# UNITED STATES PATENT AND TRADEMARK OFFICE

10/531,104

<b>Office Action Summary</b>	<b>Application No.</b> 10/531,104	<b>Applicant(s)</b> LAIHO, KIMMO	
	<b>Examiner</b> Khanh Dang	<b>Art Unit</b> 2111

## **DETAILED ACTION**

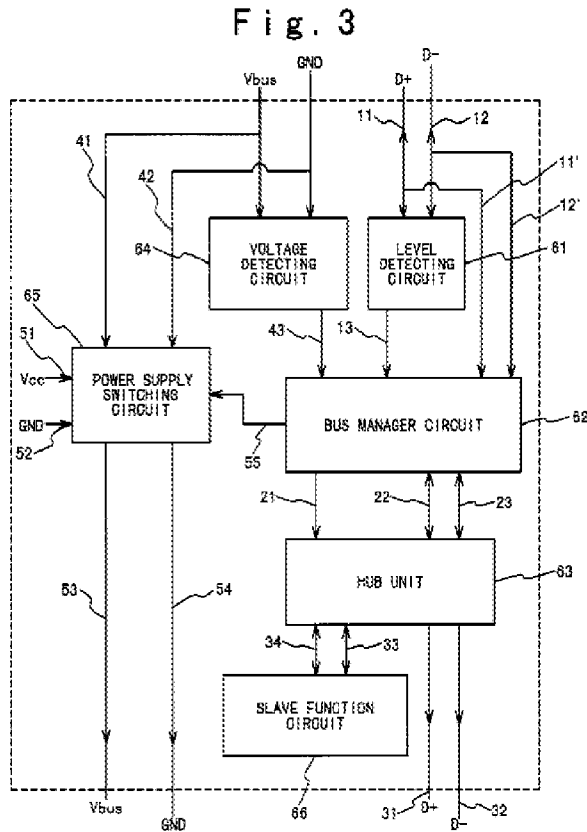
With regard to claim 1, Oguma discloses a device operable as a host device (as shown generally in Fig. 3, which is reproduced below for ease of convenience and

comprising: a port connected to a bus (as shown in Fig. 3, USB port of the portable device provides connection to the USB bus comprising Vbus, GND), means for detecting the presence of another host connected to the bus and for relinquishing host status in response thereto (the voltage detecting circuit 64 is readable as the so-called “means for detecting.” When the detecting circuit 64 detects presence of another host 1 connected to the USB bus, the host status of the portable device is

Figure 3

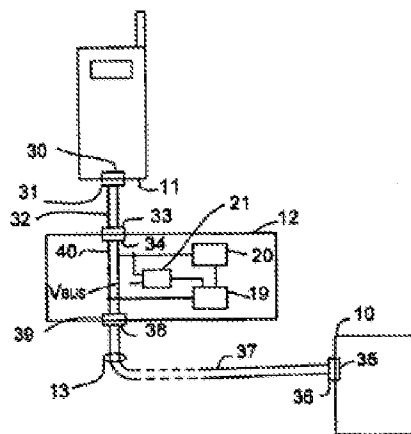
In response to Applicants' argument, at the outset, Applicants' Fig. 3 is reproduced below for comparison.

As shown in Applicants' Fig. 3, element 12 is the so-called "device operable as a host device," element 33 is the "first port," element 38 is the "second port," element 19 is the "host module," element 20 is a "comparator," and element 10 is the so-called "host externally connected to the bus."

Fig. 3

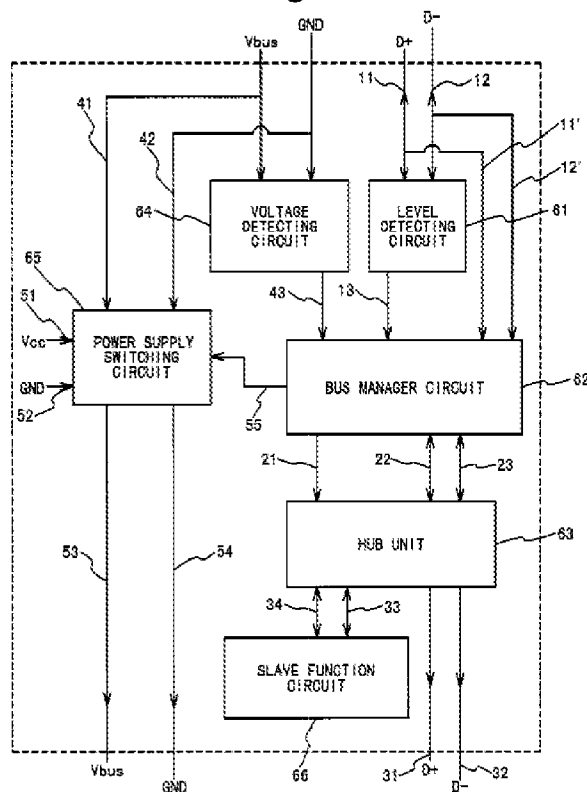
Thus, contrary to Applicants' argument, Fig. 3 of Oguma, which is reproduced below for ease of reference and comparison, shows the so-called "device operable as a

host.” Further as shown in Fig. 3, the device includes a USB bus comprising Vbus, GND, D+, and D-. The device further comprises a first upstream port connected directly to the USB bus; and a second downstream port connected directly to the same USB bus running from the first upstream USB port to the second downstream USB port. The device as shown in Fig. 3 of Oguma also shows the so-called “host module” or bus manager circuit 62 connected directly to the same USB bus; and the “comparator” or voltage circuit 64 detecting coupled to the same USB bus to detect the presence of a host externally connected to the USB bus. A voltage detecting circuit basically comprises a voltage comparator for comprising a supply voltage with a reference voltage (VREF) to detect a change in voltage or a difference between supply voltage and reference voltage. Further, as noted above, a USB bus comprises Vbus, GND, D+, and D-. It is also important to note that Applicants’ Fig. 3 shows a Vbus line, and other lines are grouped together as line 40.

Further, Applicants have argued that “Oguma imposes intervening components and circuits (which include bus manager circuit 62, hub unit 63, and power supply switching circuit 65) to perform any sort of pass-through function.” In response to Applicants’ argument, at the outset, it is noted that Applicants have acknowledged that the signal is indeed passed through from host to device without any modification to the signal. As a matter of fact, Oguma clearly discloses that the bus manager circuit 62 only passes the USB signals. Thus, USB data are communicated between the slave function circuit 66, the host personal computer 1, and the third external device 6 via the USB hub unit 63. The USB hub, by definition, is essential transparent. What is sent by the host is received by the device. See definition of USB Hub provided by Wikipedia, cited below.

Thus, it is clear that the bus manager circuit 62 as well as the hub 63 allow the USB data to pass through directly from the host to the device without any USB signal intervention and/or modification. In other words, the USB data bus passes the USB signal directly from the first port to the second port (the ports are used to connect the host to the device) in response to the relinquishment of host status.
